South Texas Project Electric Generating Station P.O. Box 289 Wadsworth, Texas 77483

December 21, 2010
U7-C-STP-NRC-100274

South Texas Project
Units 3 and 4
Docket Nos. 52-012 and 52-013
Supplemental Response to Request for Additional Information

RAI 03.07.01-27, Supplement 1**QUESTION:****Follow-up Question to RAI 03.07.01-19 (STP-NRC-100093)**

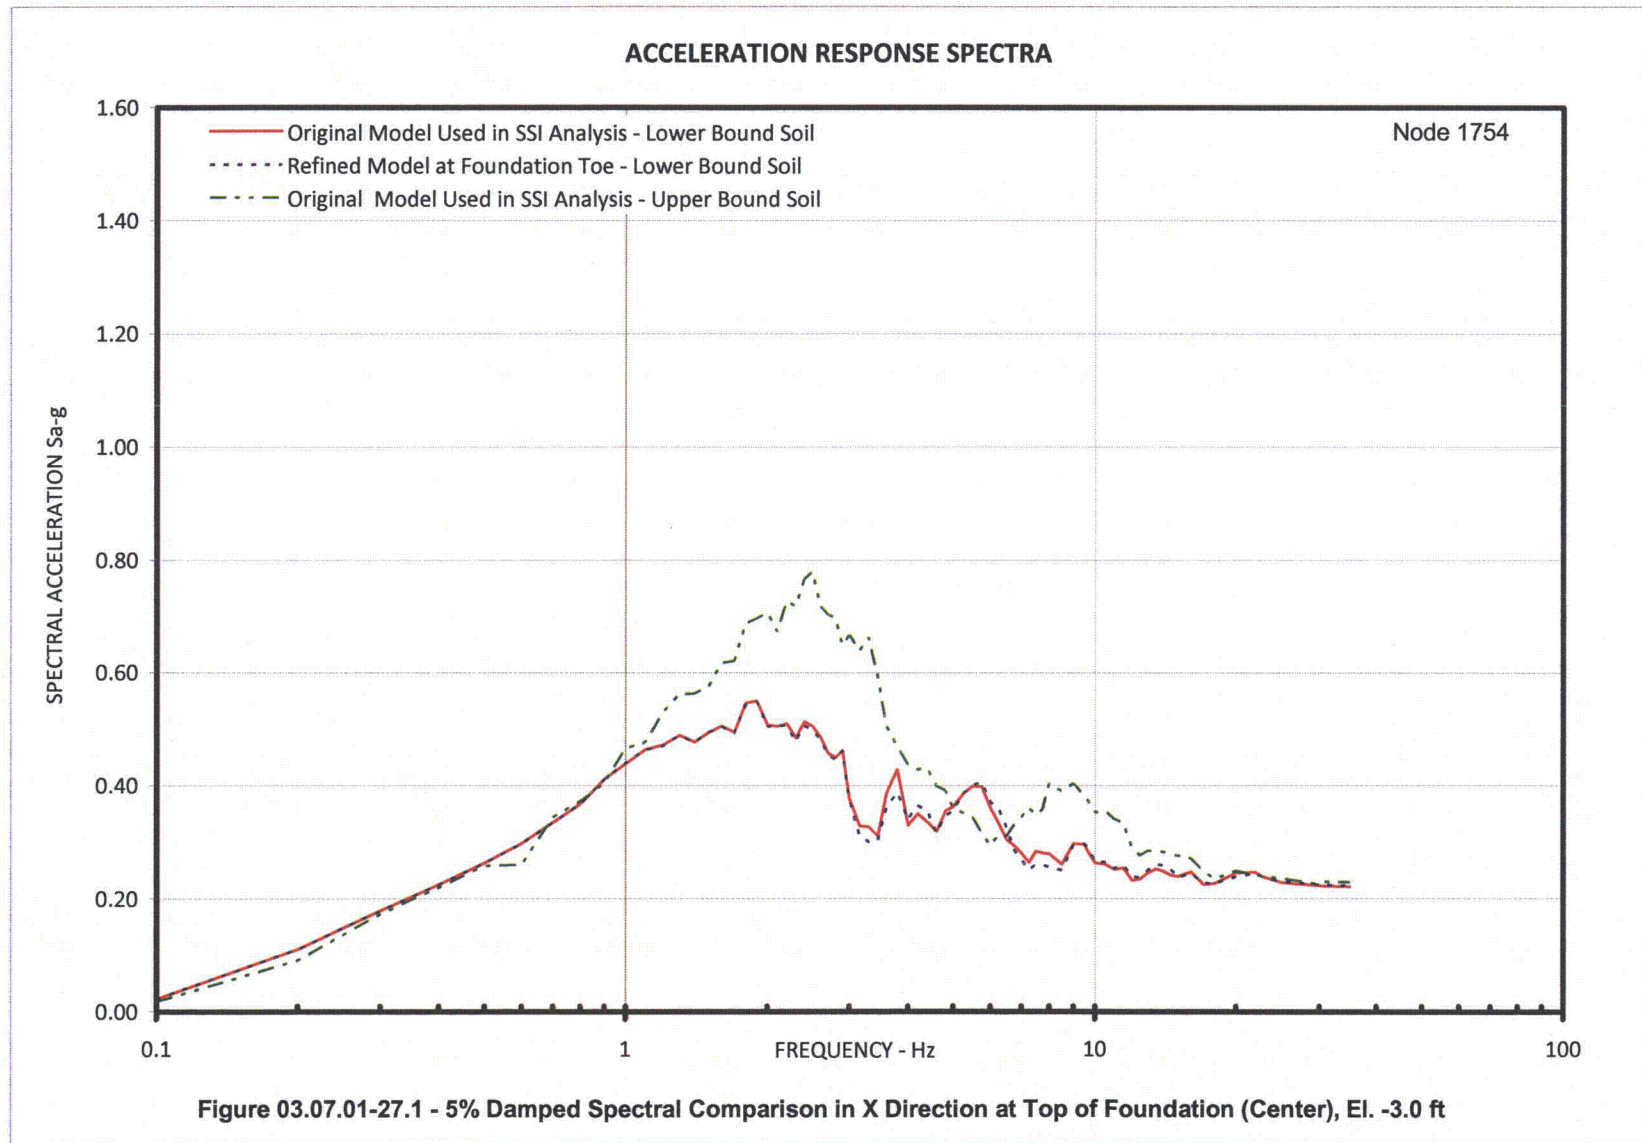
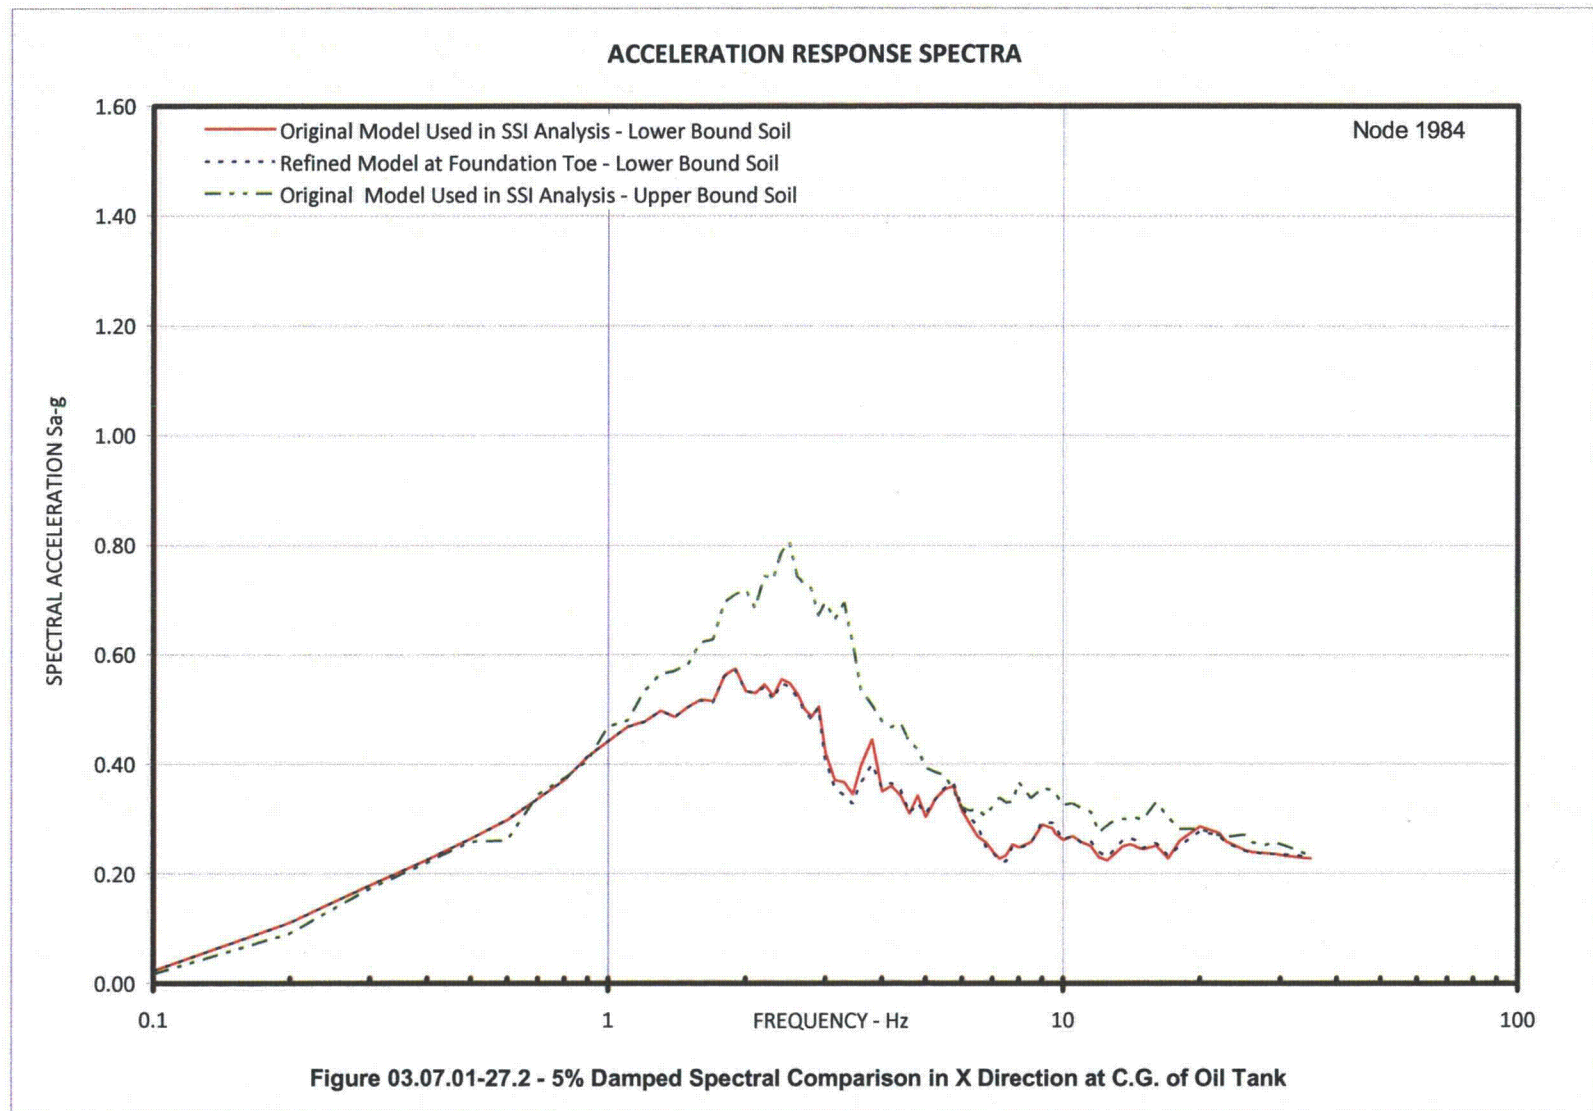
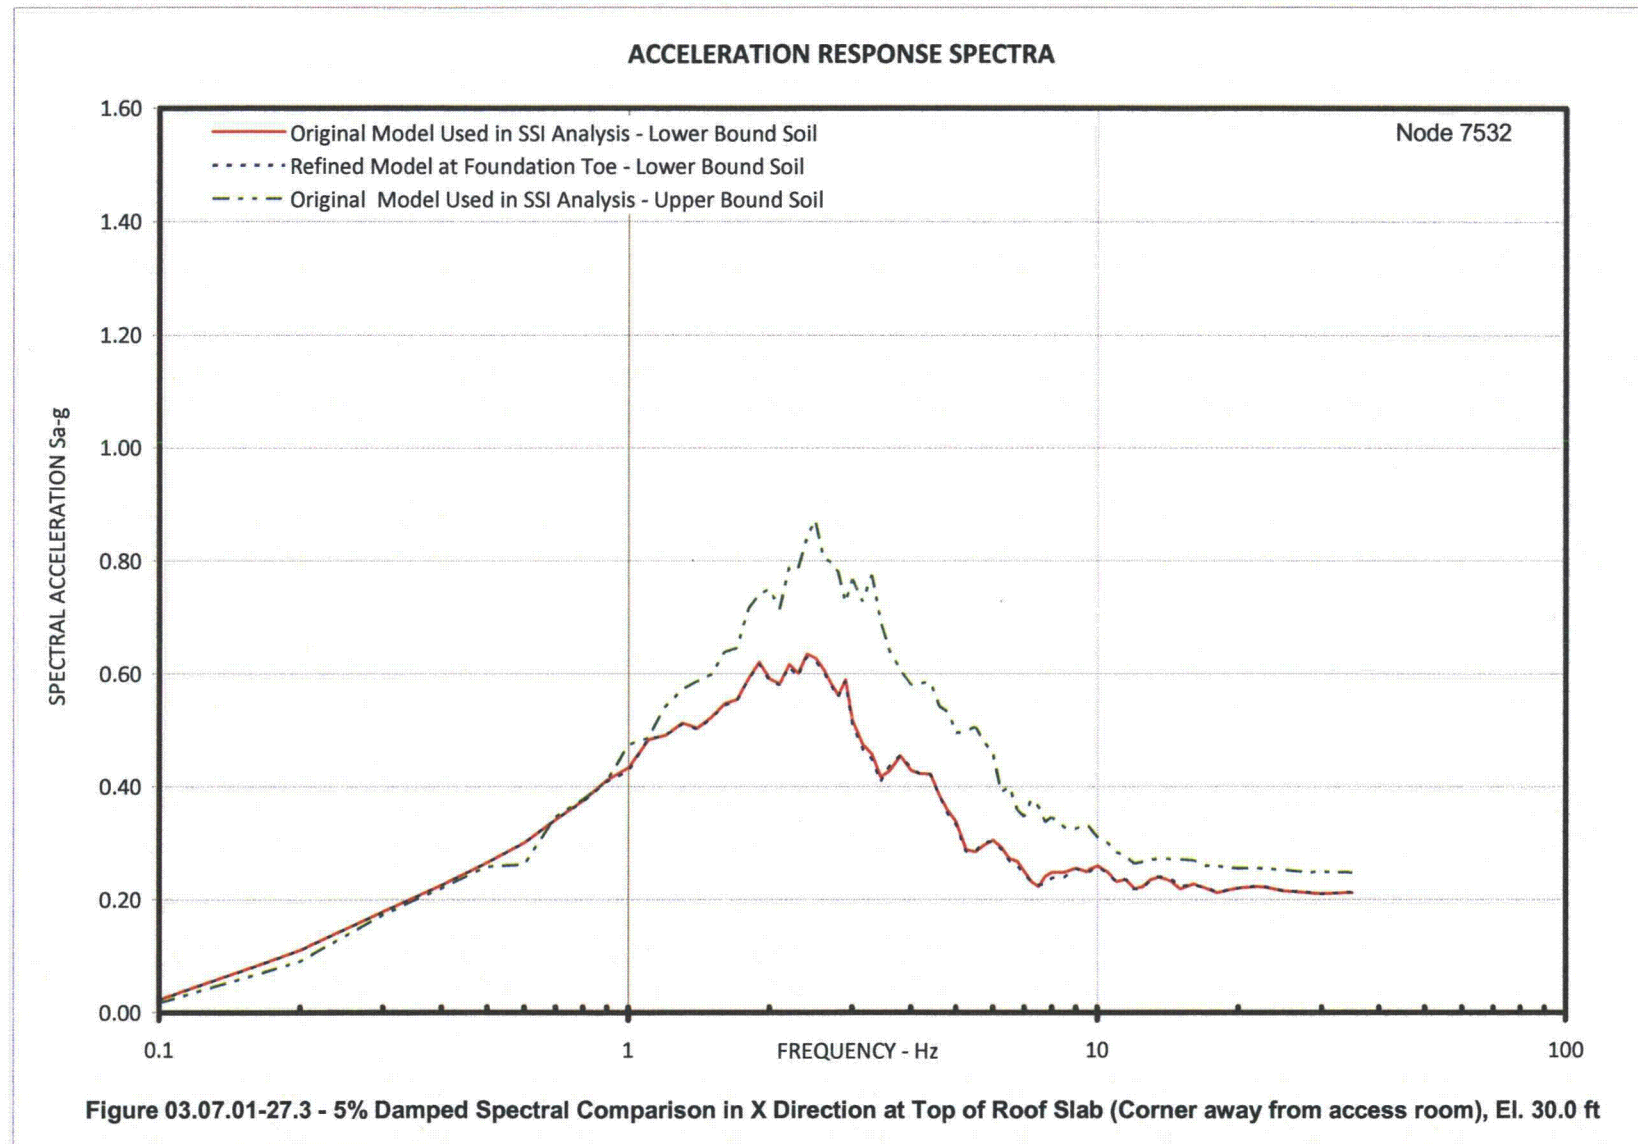
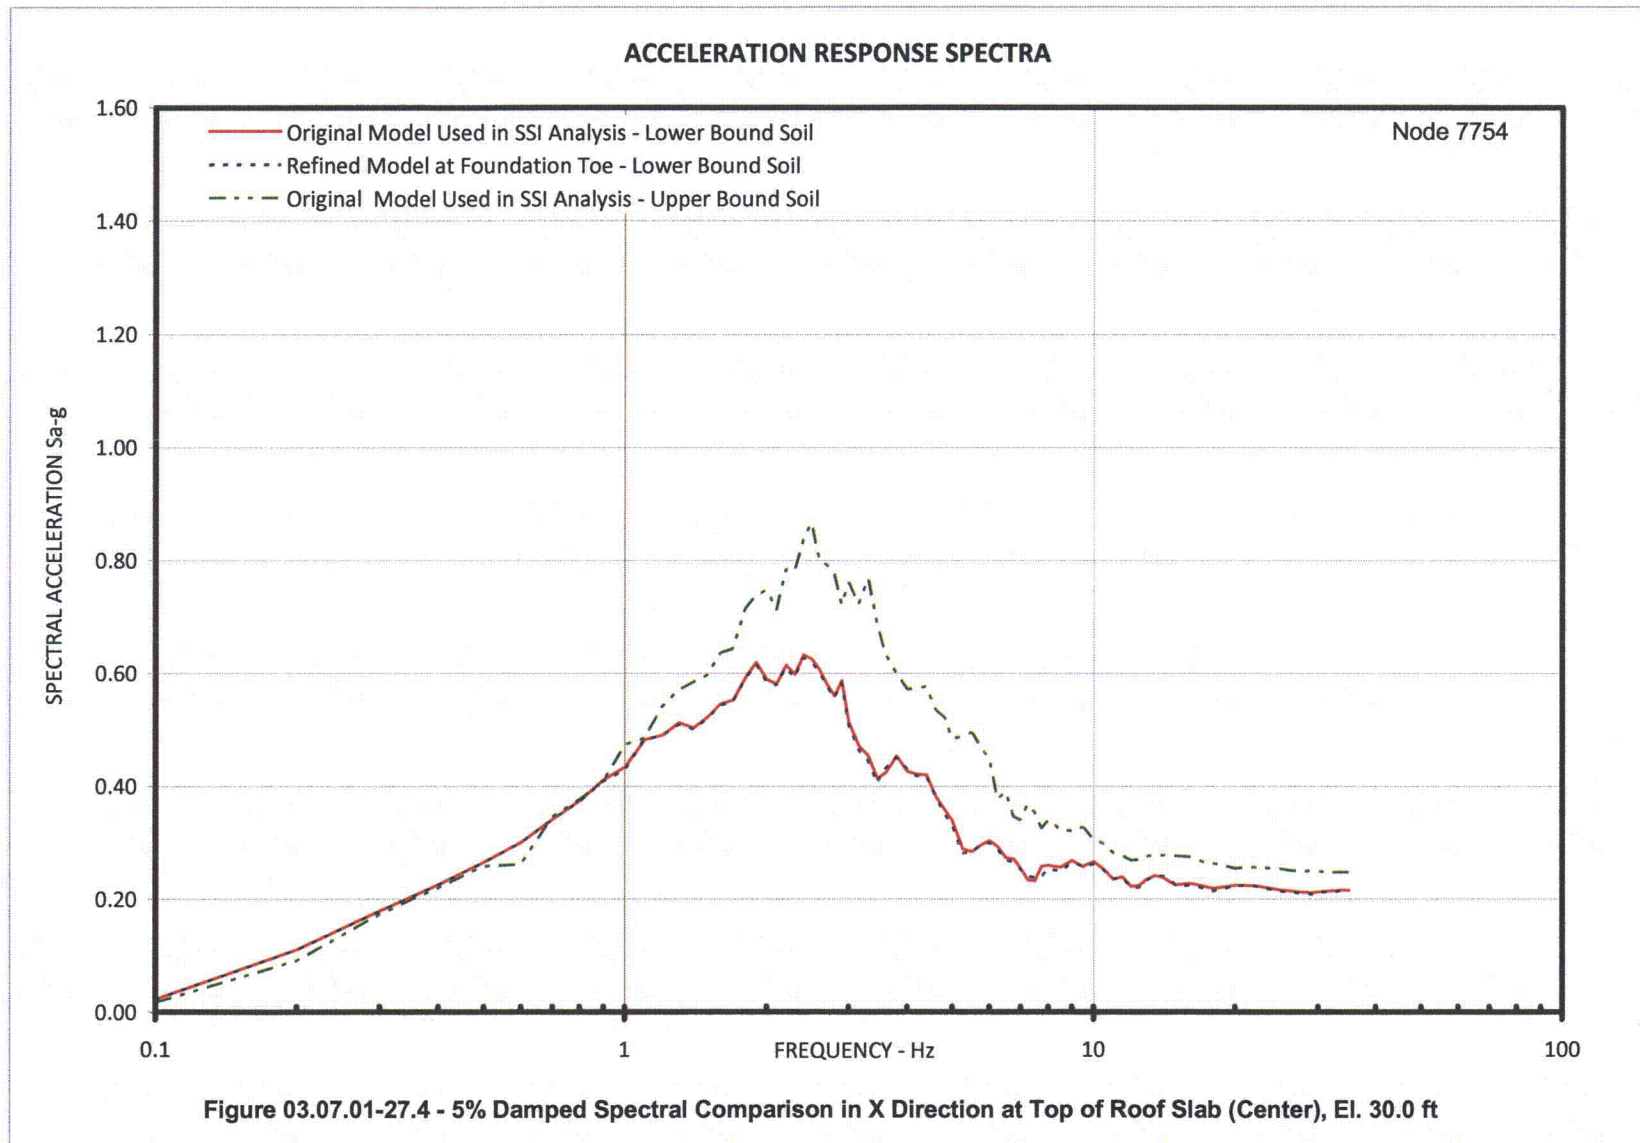
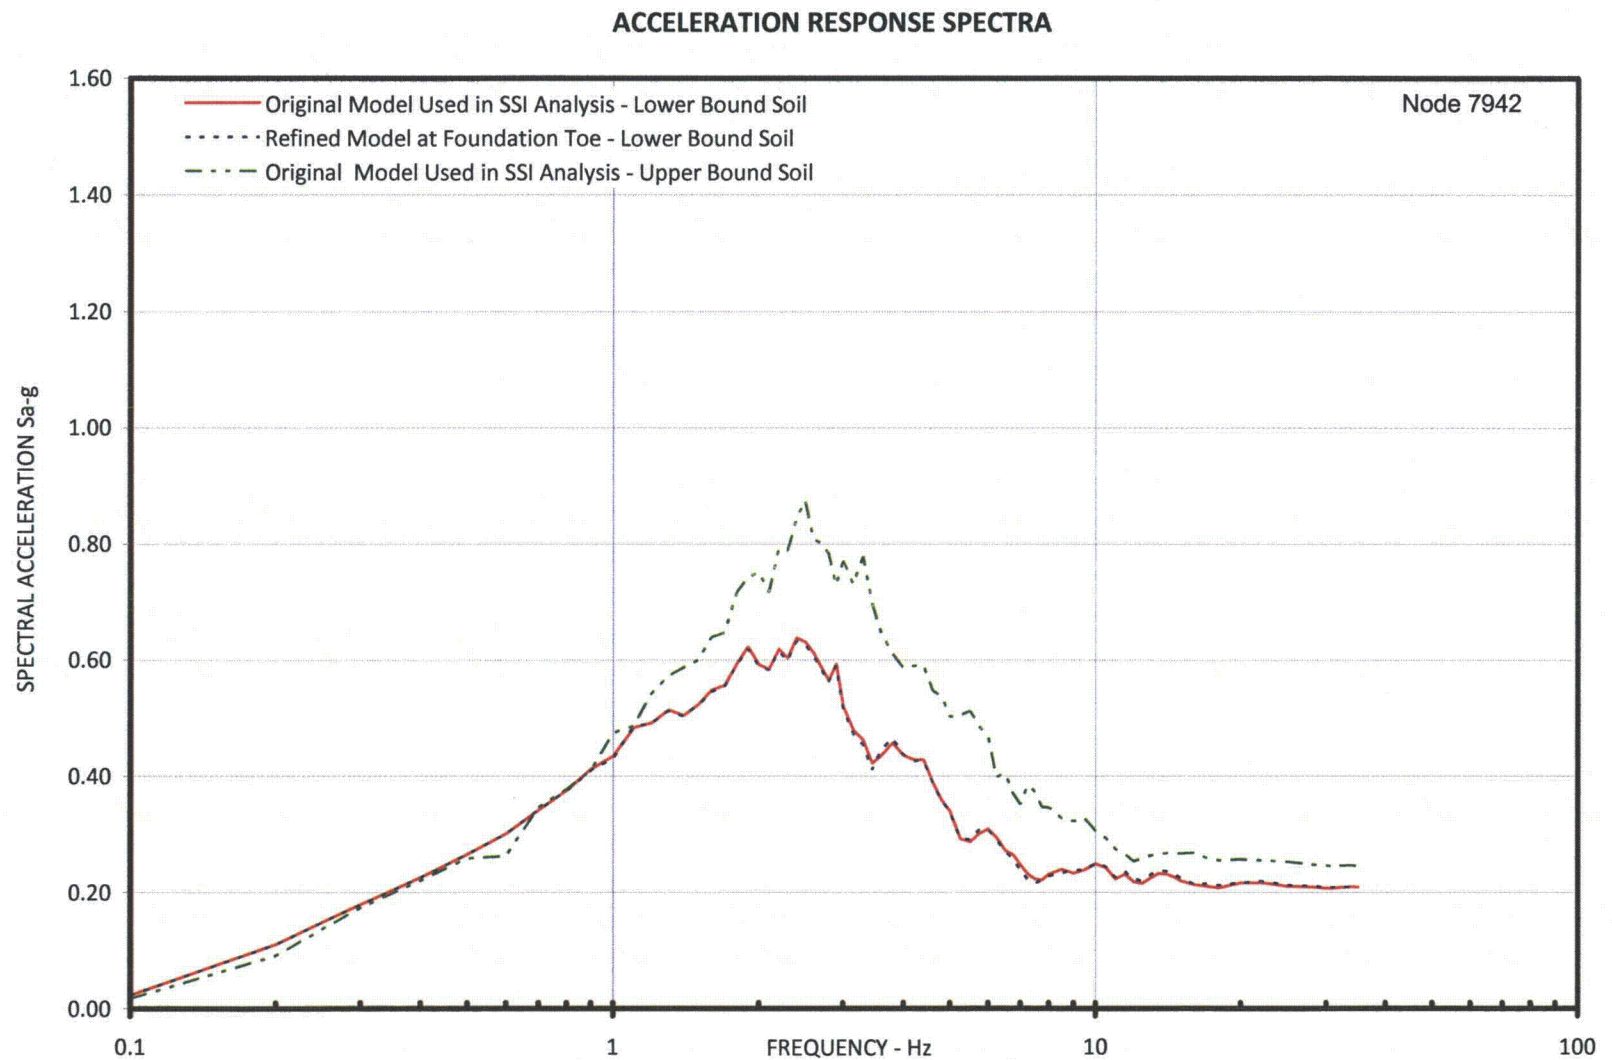
- (a) Describe in detail the method used for the SSI analysis of DGFOVS including the procedures for treatment of strain dependent backfill material properties in the model, input motion used and how it is specified in the analysis, variation of soil properties, and the computer programs used for SSI analysis.

To evaluate the effect of 20 Hz passing frequency for LB in-situ case, the foundation toe was divided into two elements, thus increasing the passing frequency to 40 Hz. This refined model with LB in-situ soil properties was analyzed and 5% damped spectra from this model were compared with the spectra from the original model with passing frequency of 20 Hz. The spectra comparison plots are shown in Figures 03.07.01-27.1 through 03.07.01-27.24. The comparison shows that:

- In the X direction, there is insignificant difference between the response spectra from the two models
- In the Y direction, the response spectra from the two models matched well except at frequency of about 3.8 Hz where the refined model produced higher spectra. However, spectra from both the models are enveloped by the spectra for UB in-situ soil case
- In the vertical direction, the spectra from the two models matched well (insignificant difference)

Based on the above evaluation it is concluded that the horizontal direction passing frequencies are acceptable.
